# Z-17

**ZONING COMMENTS:**

Applicant is requesting the Neighborhood Retail Commercial (NRC) zoning category in order to develop a childcare center. The building will be an 11,400 square-foot, one-story brick building as depicted on the attached elevations. The hours of operation will be 6 a.m. to 7 p.m., Monday through Friday. The applicant has indicated there will be up to 120 students. This is not a private school.

SITE PLAN FOR  
**Chuck Gwude**  
 Land Lot 789 & 840  
 19th District  
 Cobb County, Georgia  
 Date: March 01, 2013 Scale: 1"=20'

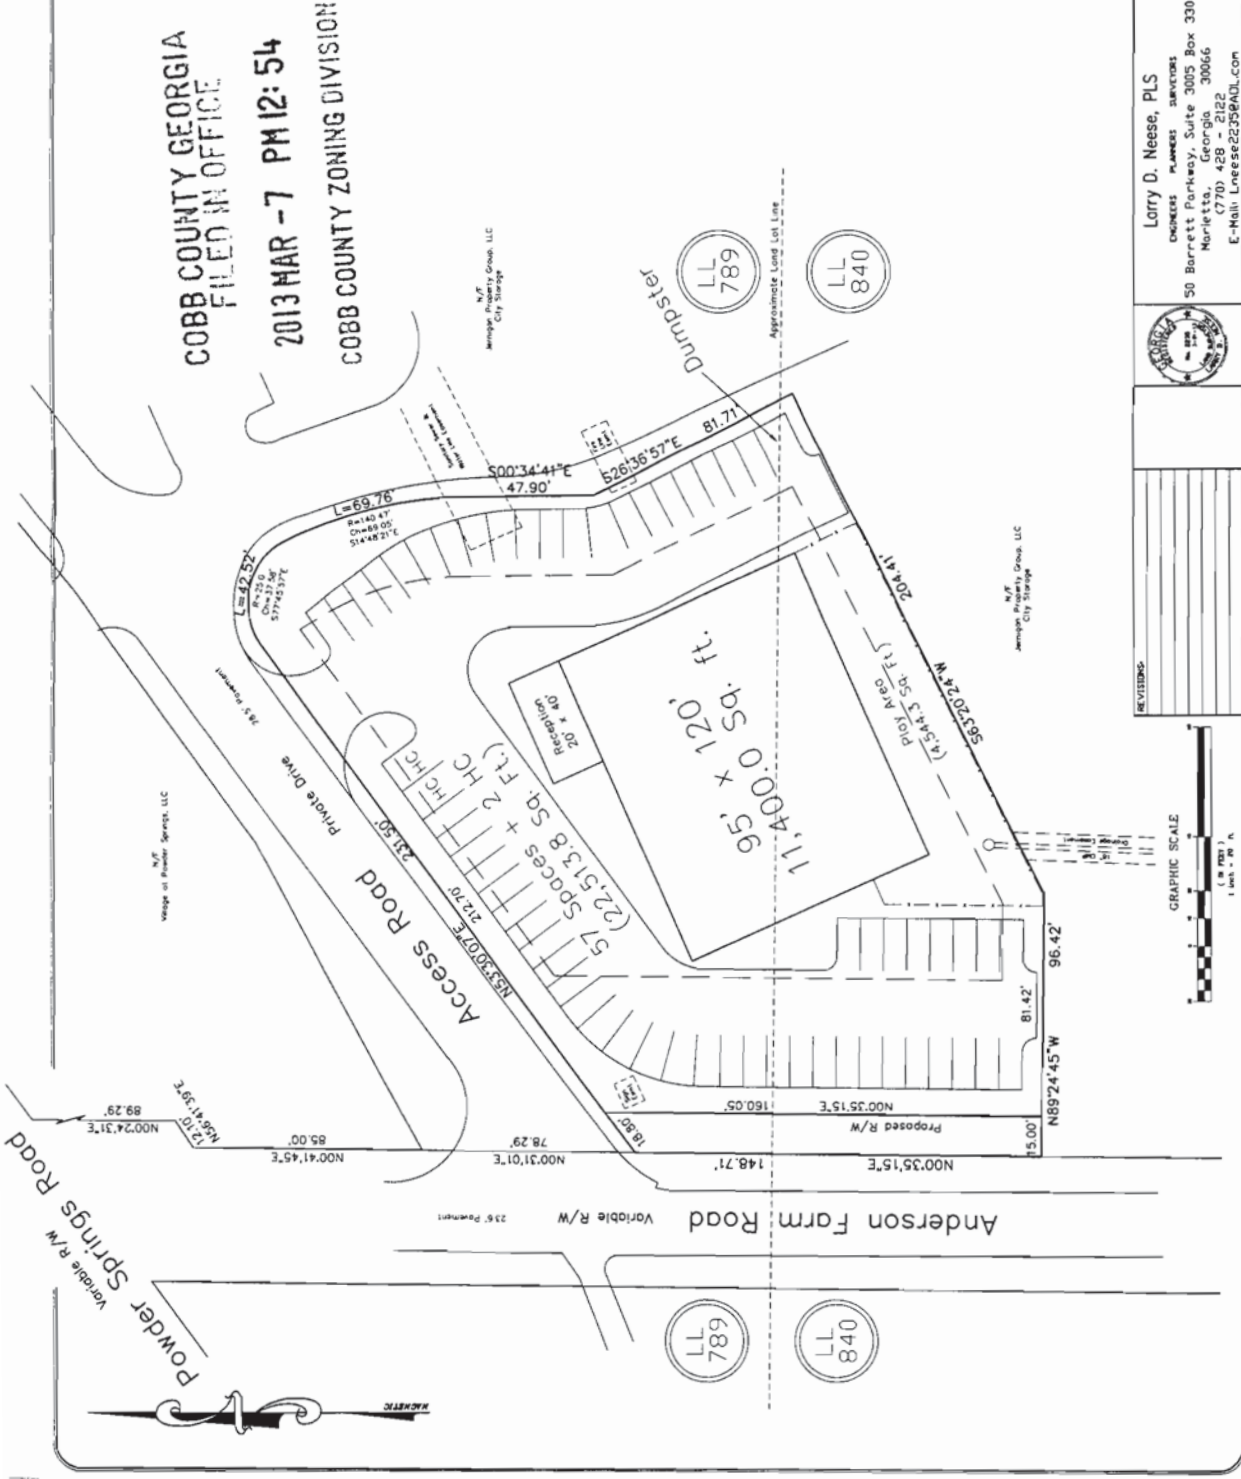
- No Stormwater controls shown \_\_\_\_\_
- Copy of survey is not current – Additional comments may be forthcoming when current site conditions are exposed.
- No site improvements showing on exhibit.

1. Detention is to be provided in the existing master stormwater management facility. The proposed site plan must comply with the allowable design impervious coverage.

Old Anderson Farm Road is classified as a local and according to the available information the existing right-of-way does not meet the minimum requirements for this classification.

Recommend no access to Old Anderson Farm Road. All access should be off the Access Road shown on the plan.

Recommend applicant consider entering into a development agreement pursuant of O.C.G.A. 36-71-13 for dedication of the following system improvements to mitigate traffic concerns: a) donation of right-of-way on the east side of Old Anderson Farm Road, a minimum of 50' from the roadway centerline.

Recommend sidewalk along the Old Anderson Farm Road frontage.
